**ALAMEDA COUNTY CONSTRUCTION MANAGEMENT AGENCY**  
**I-580 TMP/ADVANCED ELEMENT PROJECT**  
**Project No. 03-06**  
**Questions from Potential Bidders**  
**Last updated: October 2, 2006**

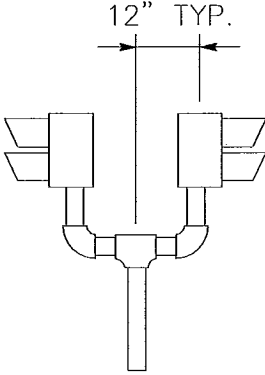
3	<p>In regards to the TSP installation:</p> <ol style="list-style-type: none"> <li>1) Are we supposed to remove existing equipment and install the new ones as shown in the existing and proposed detail on sheet E-64 and E-65?</li> <li>2) Can we use the same detector stub to install the new one?</li> <li>3) In detail B can we use 2Ch-2 Direction detector to utilize the same stub in the mast arm instead on installing another one?</li> </ol>	<ol style="list-style-type: none"> <li>1) Yes, it is assumed if the cabinet equipment needs to be upgraded then the mast arm equipment needs to be upgraded.</li> <li>2) Yes, the same detector stub can be used unless there is some existing damage.</li> <li>3) The Opticom equipment will be Agency furnished, and it is preferred to use model 721 (one directional detector). For the Northwest corner of Brisa/Vasco two detectors can be mounted on one stub with a 'Y' mounting hardware that would be Contractor furnished. See diagram below.</li> </ol> <p><b>TSP Mounting Detail</b></p> 	9/28/06
